Architectural Commission Report

Meeting Date: Wednesday, March 18, 2015

Subject: **TIFFANY & CO. (PL1503127)**
210 North Rodeo Drive

Request for approval of a façade modification, a sign accommodation for multiple business identification signs, building identification signs, and a construction barricade graphic. The Commission will also consider adoption of a Categorical Exemption, pursuant to the California Environmental Quality Act.

② EXISTING FACADE ELEVATION AT VIA RODEO
SCALE: 1/8" = 1'-0"

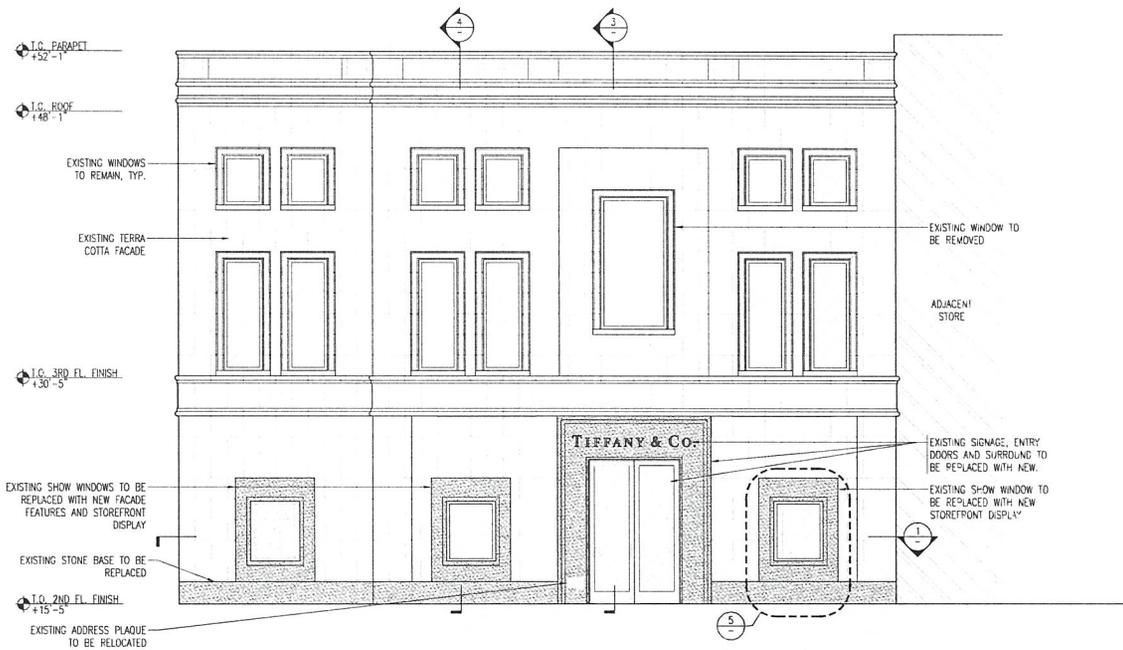
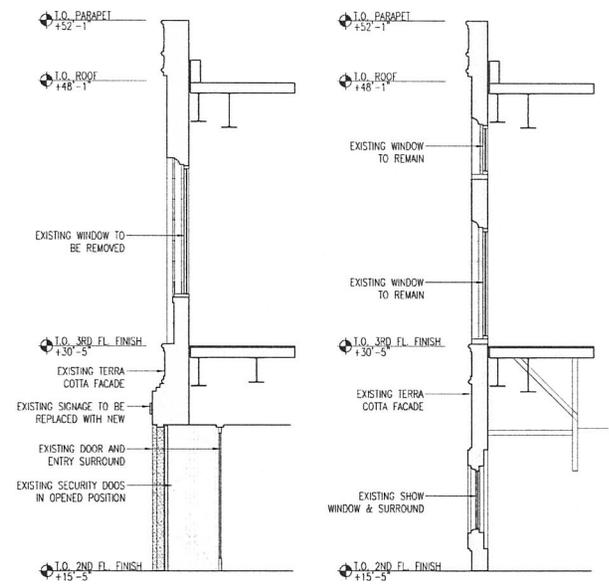
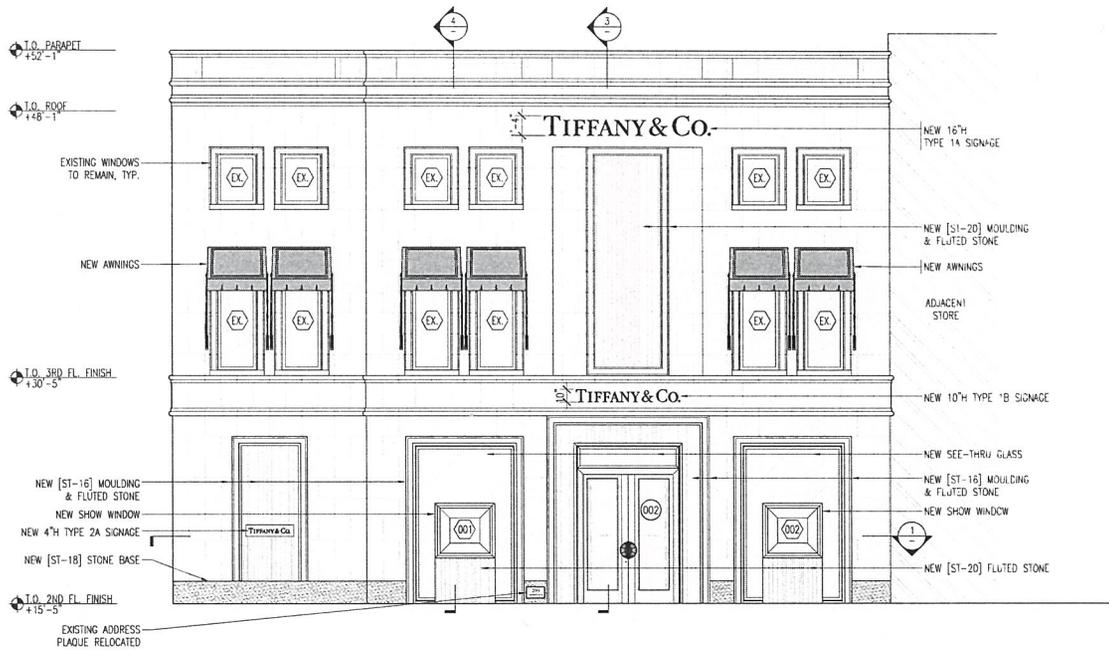
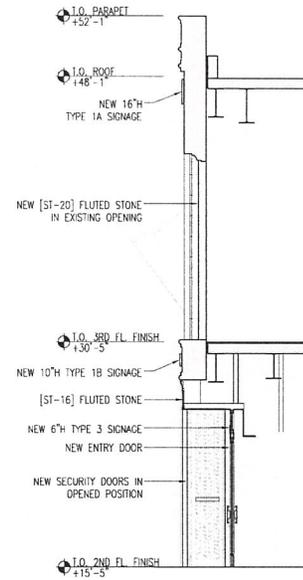
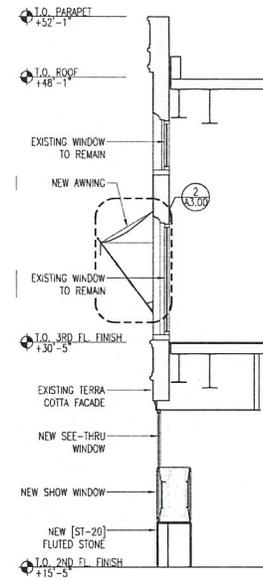
However, on the Via Rodeo elevation, it is recommended that a storefront display window be created where the location plaque is proposed for removal. This will assist in creating greater transparency between the interior and exterior spaces within the Via Rodeo development.
